Access Compliance Report Public Rights-of-Way (Pedestrian Signals)

Intersection ID: N/A	Main Street:	Cross Street: N/A	Location: N/A
ADA ID: F06524933E95	Signal Type: Two Push Buttons-Non APS	Overall Compliance: No	Severity Score: BTN 1:N/A BTN 2: N/A No BTN: N/A
Codes/Mitigation Info/Possible Solution		Field Measurements/Component Compliance

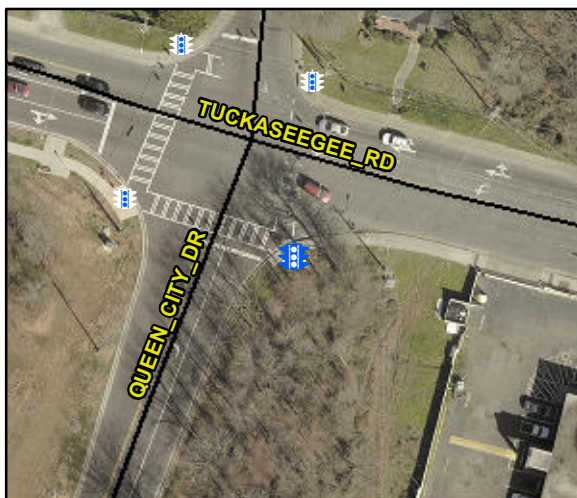
Possible Solutions: Remove and Replace Clear Space.

PROW/ADA: R404.2, R404.3, R404.7.2
